UNITED STATES
DEPARTMENT OF THE INTERIOR
BUREAU OF LAND MANAGEMENT

RECEIVED
JAN 18 2011FORM APPROVED
OMB NO. 1004-0135
Expires: July 31, 2010**SUNDRY NOTICES AND REPORTS ON WELLS**
*Do not use this form for proposals to drill or to re-enter an abandoned well. Use form 3160-3 (APD) for such proposals.***SUBMIT IN TRIPLICATE - Other instructions on reverse side.**

HT Federal No. 5

Cimarex Energy Co. of Colorado

5000# BOP tested to 3000#

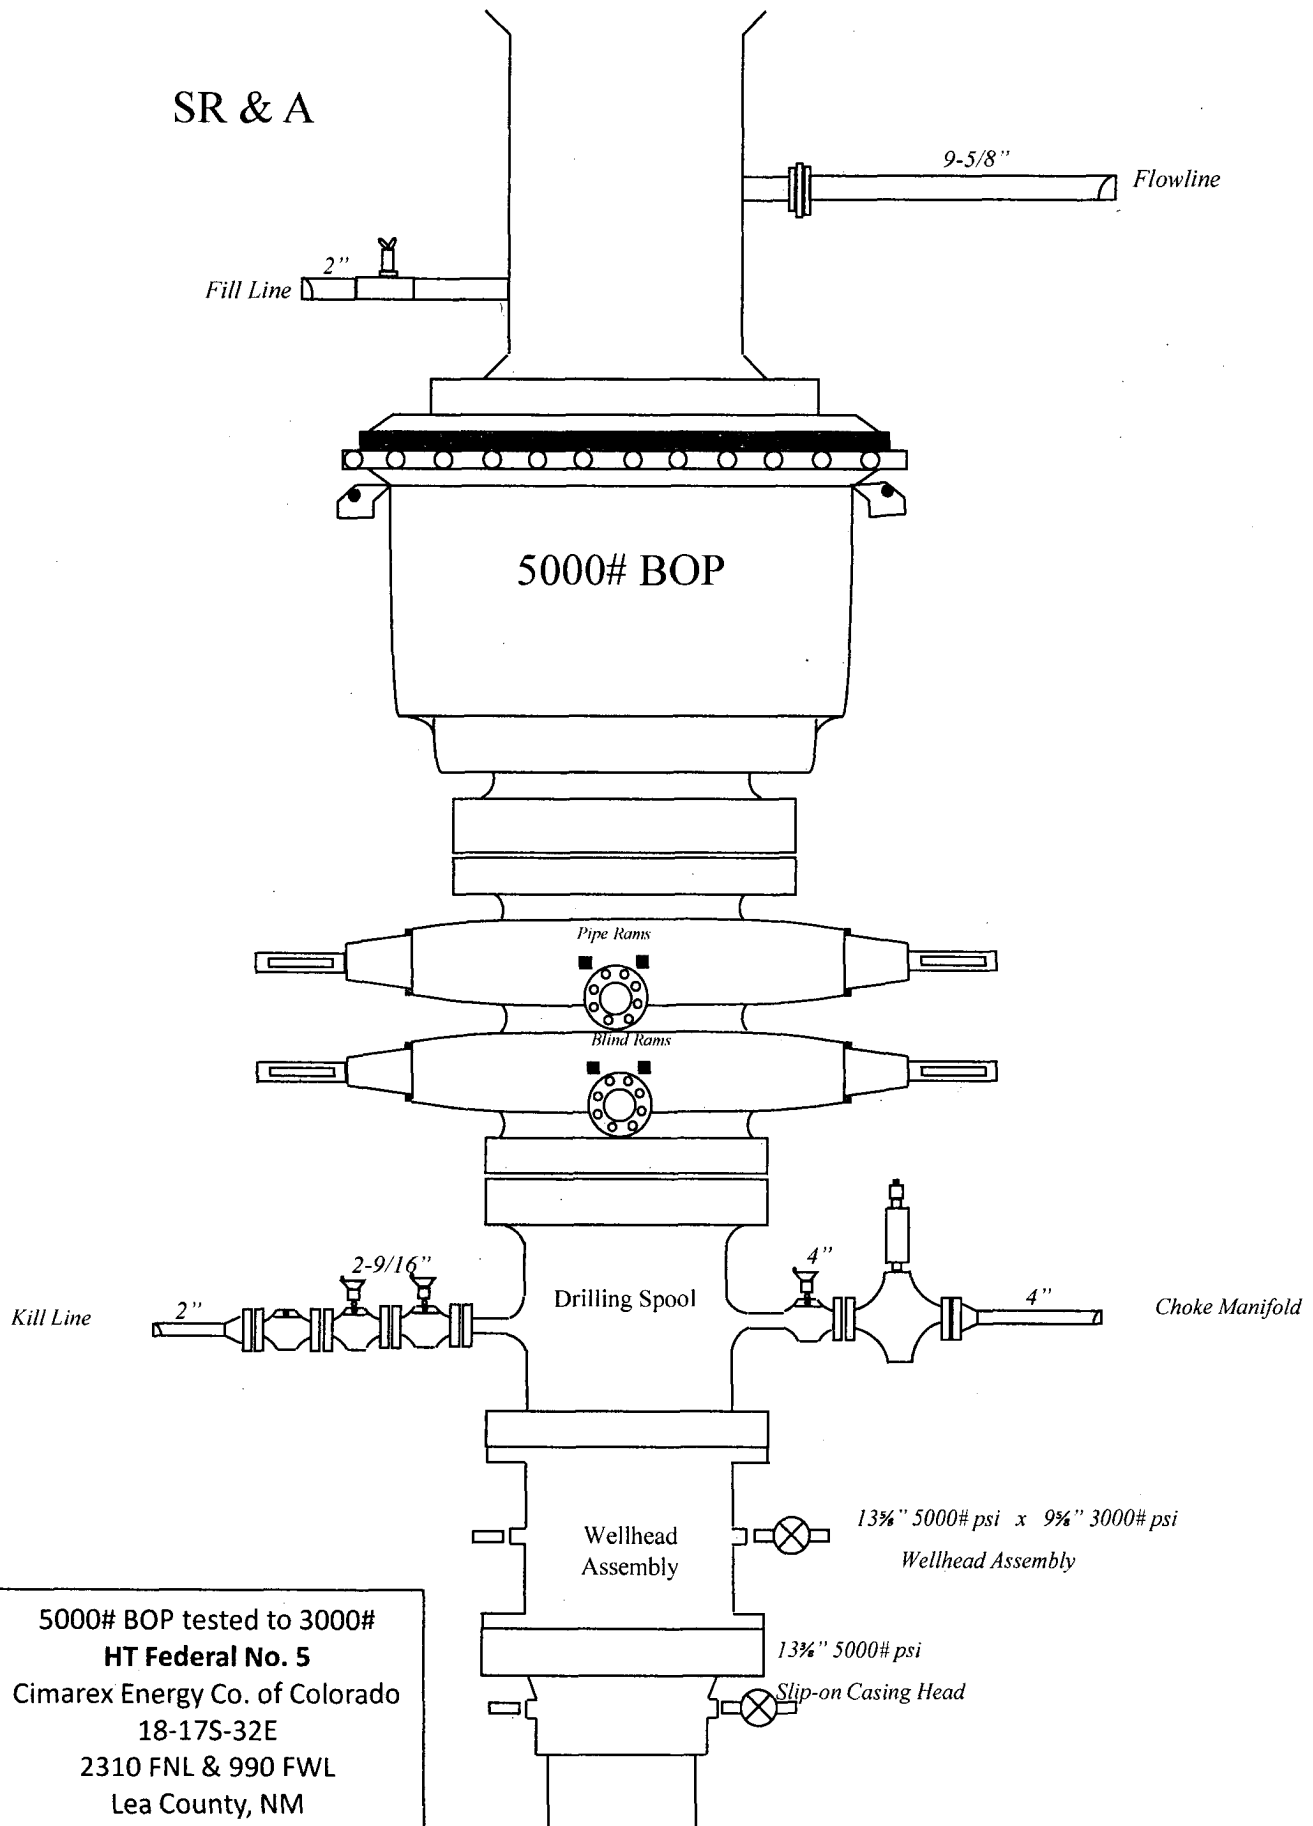
Cimarex has changed plans regarding the BOP. Please see revised BOP description below, and attached revised BOP diagrams.

A 13-5/8" 5000 PSI working pressure BOP tested to 3000 psi consisting of one set of blind rams and one set of pipe rams and a 5000# annular type preventer. A choke manifold and 120 gallon accumulator with floor and remote operating stations and auxiliary power system. Rotating head as needed. A kelly cock will be installed and maintained in operable condition and a drill string safety valve in the open position will be available on the rig floor.

BOP unit will be hydraulically operated. BOP will be nipped up and operated at least once a day while drilling and the blind rams will be operated when out of hole during trips. No abnormal pressure or temperature is expected while drilling. From the base of the surface pipe through the

running of production casing, the well will be equipped with a 5000 psi BOP system tested to 3000 psi.

BOPS will be tested by an independent service company to 250 psi low and 3000 psi high. Hydril will be tested to 250 psi low and 3000 psi high.
